Access Compliance Report

Public Rights-of-Way

(Curb Ramps)

Intersection ID: 44164	Main Street: MEADOW_KNOLL_DR	Cross Street: COCHRANE_DR	Location: SE
ADA ID: 09EE3750FF02	Ramp Type: PerpDiag	Initial Pass/Fail: Fail	Overall Compliance: No
Severity Score: 46.25			
Codes/Mitigation Info/Possible Solution		Field Measurements/Component Compliance

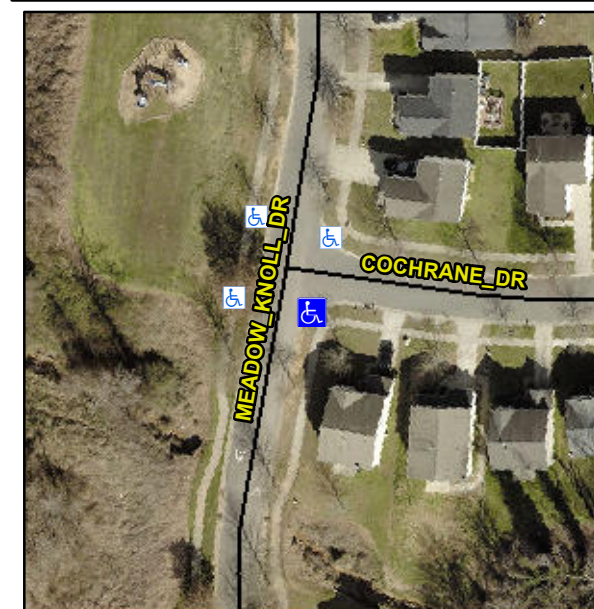
Not Found, R304.5.1, R304.2.2, R304.5.3

Compliance	Description	Data	Compliance	Description	Data
N/A	Ramp Length (in)	84.5	No	Ramp Slope (%)	11.4
No	Ramp Width (in)	47.0	No	Ramp XSlope (%)	8.6
N/A	Flare Type LT	N/A	N/A	Flare Type RT	N/A
N/A	Flare Slope LT (%)	N/A	N/A	Flare Slope RT (%)	N/A
N/A	Flare Traversable LT?	N/A	N/A	Flare Traversable RT?	N/A
N/A	Landing Length (in)	N/A	N/A	DWS Provided?	N/A
N/A	Landing Width (in)	N/A	N/A	DWS Contrast?	N/A
N/A	Landing Slope (%)	N/A	N/A	DWS Length (in)	N/A
N/A	Landing X Slope (%)	N/A	N/A	DWS Full Width?	N/A
N/A	Landing Curb? (Y/N)	N/A	N/A	DWS Offset (in)	N/A
N/A	Shared Landing?	N/A			
N/A	Gutter Ponding?	N/A	N/A	Gutter Slope (%)	N/A
N/A	Gutter Lip Ht (in)	N/A	N/A	Gutter X Slope (%)	N/A
N/A	Painted X Walk1?	No	N/A	Painted X Walk2?	No
	X Walk 1 Direction	To N		X Walk 2 Direction	To W
N/A	X Walk 1 Width (in)	N/A	N/A	X Walk 2 Width (in)	N/A
	X Walk 1 Slope (%)	9.8		X Walk 2 Slope (%)	0.2
	X Walk 1 X Slope (%)	3.0		X Walk 2 X Slope (%)	7.8

Remove & Replace Curb Ramp With Two New Directional Ramps or Equivalent.
